DIP/HMR SUBDIVISION

APPLICATION NUMBER 16 DATE November 1, 2007

REQUEST Subdivision

DETAIL SITE PLAN

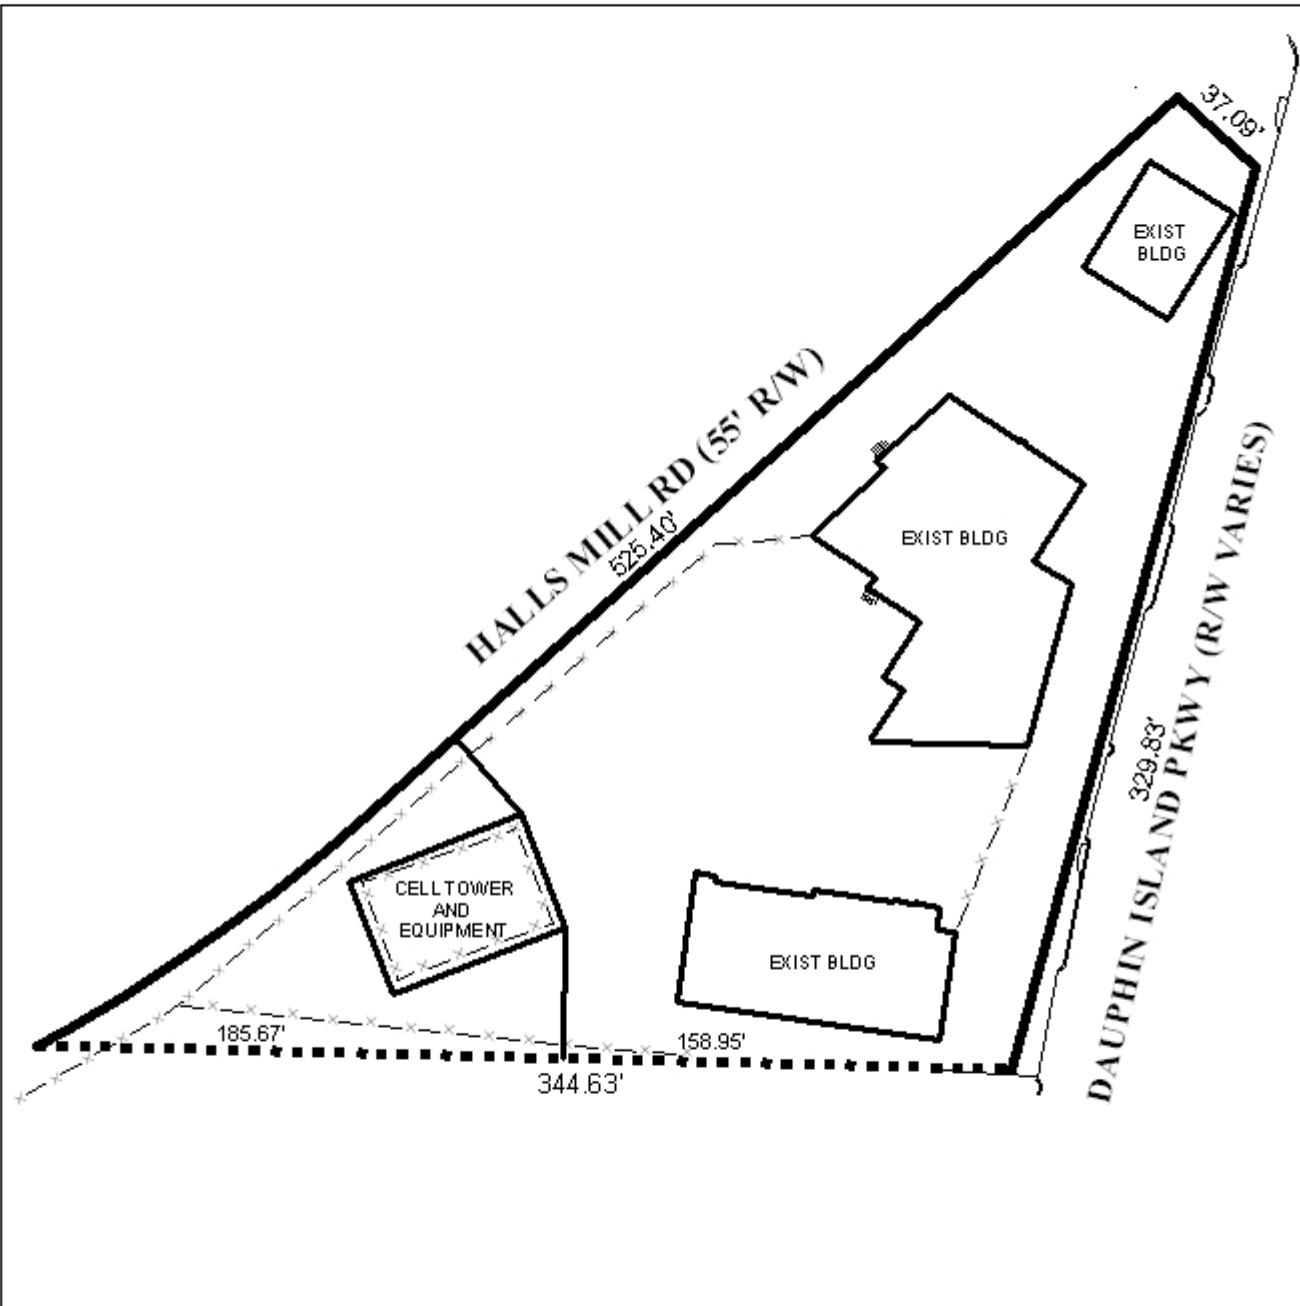
The site fronts Dauphin Island Parkway and Halls Mill Road. Dauphin Island Parkway has a variable right-of-way, and Halls Mill Road has 55 feet of right-of-way. Both are major streets; therefore the final plat should be revised to provide 50 feet of right-of-way from the centerline of each street, compliant with the major street plan.

The proposed Lot 1 has approximately 380 linear feet of frontage along Halls Mill Road and 560 linear feet of frontage along Dauphin Island Parkway. Lot 2 has approximately 145 linear feet of street frontage on Halls Mill Road. Since both streets are major streets with heavy traffic, access management is a concern; therefore, a note should be placed on the final plat stating that Lot 1 is limited to two curb cuts to each street, and Lot 2 shall be limited to one curb cut to Halls Mill

Road, with the size, location and design to be approved by Traffic Engineering and conform to AASHTO standards.

There is no depiction of the 25 foot minimum building setback line, which shall be addressed prior to signing the final plat.

Proposed Lot 1 contains 3 existing buildings. If these buildings are to remain, an application for Planned Unit Development (PUD) will be required. Removal of the existing buildings on Lot 1 will require appropriate permits. Proposed Lot 2 contains a cell tower with supporting equipment. Any additional structures on Lot 2 may require an application for an *administrative* PUD.

- 1) provision of 50 feet of right-of-way measured from the centerline of each street;
- 2) the depiction on the final plat of the 25' front setback line along Halls Mill Road and Dauphin Island Parkway;
- 3) placement of a note on the final plat stating that the Lot 1 is limited to two curb cuts to each street, and Lot2 is limited to one curb cut to Halls Mill Road, with the size, location, and design to be approved by Traffic Engineering, and conform to AASHTO standards;
- 4) submission of a PUD application if existing buildings are to remain on Lot 1 site;
- 5) submission of an application for an *administrative* PUD if additional structures are proposed for Lot 2; and
- 6) compliance with Section V.A.7. of the Subdivision Regulations.
